ADDENDUM #2  
Water System Improvements – Proposed Booster Pump Station  
Village of Port Sanilac  
April 24, 2024

The following clarifications and additions are to be incorporated into the construction plans, bidding and contract documents:

REV: A-1  
JOB No: 20C0018

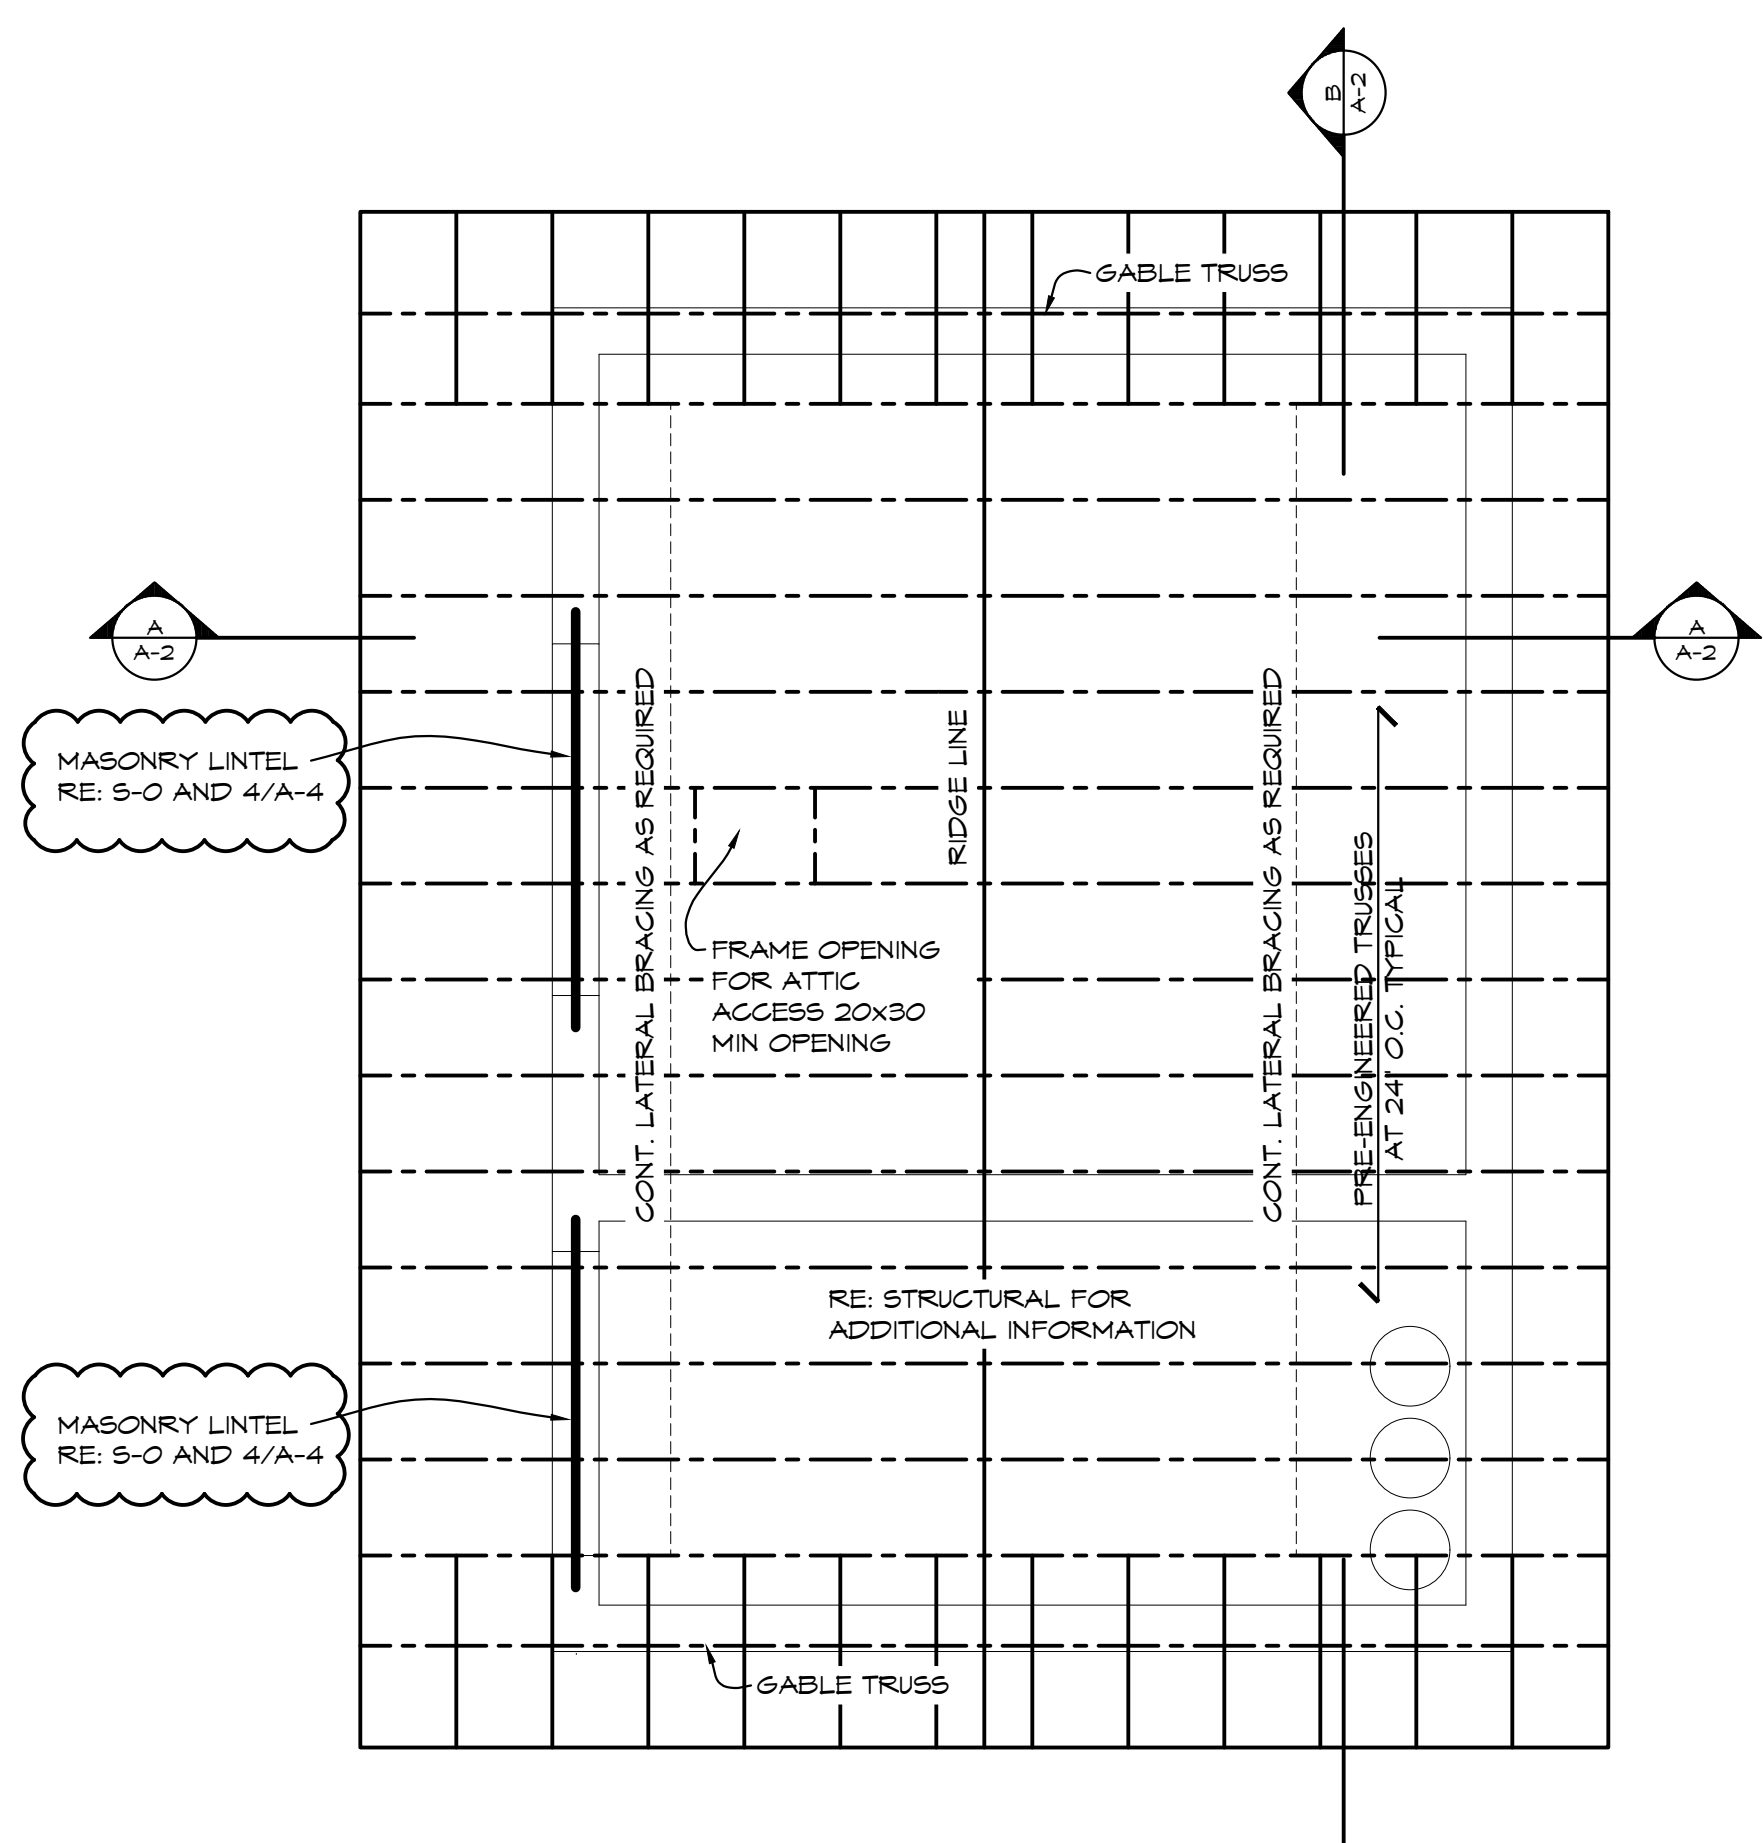
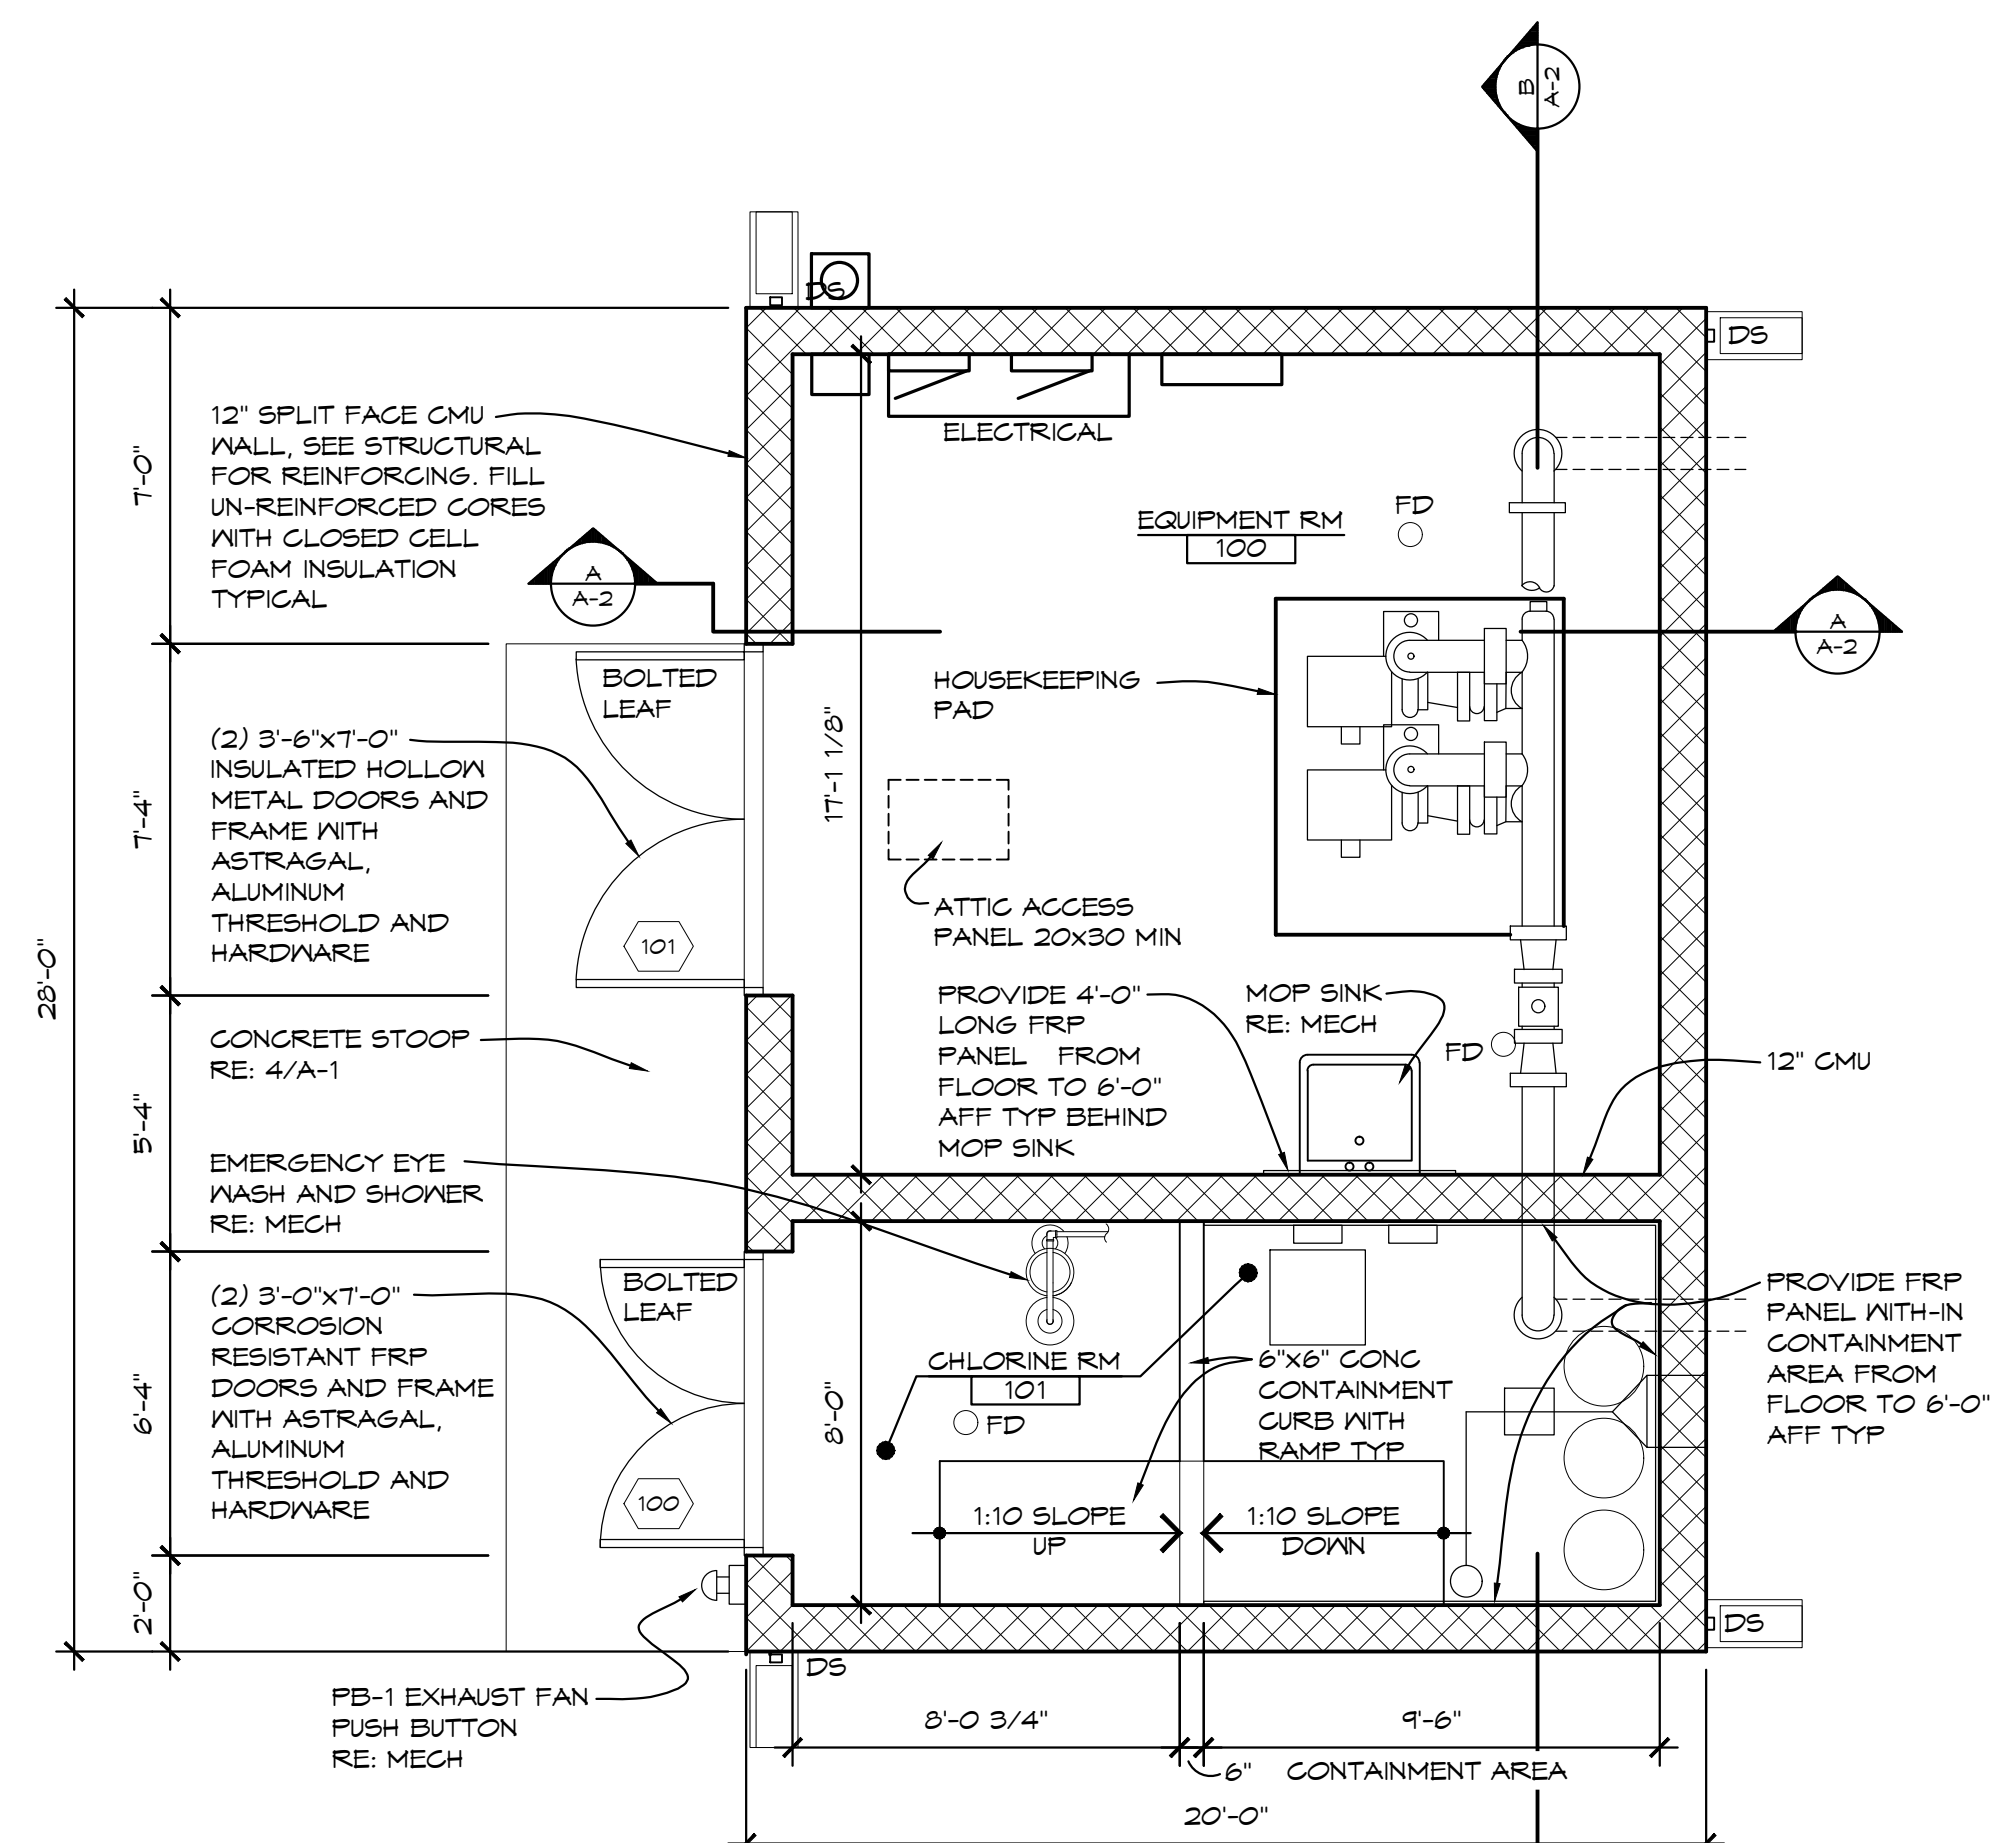
1. Refer to Drawing Sheets S-0, A-1, and A-4. (see attached)  
Lintel over door 100 and 101 has been revised, see detail 4/A-4.

LINTELS (2) COURSE MASONRY LINTEL RE: 4/A-4
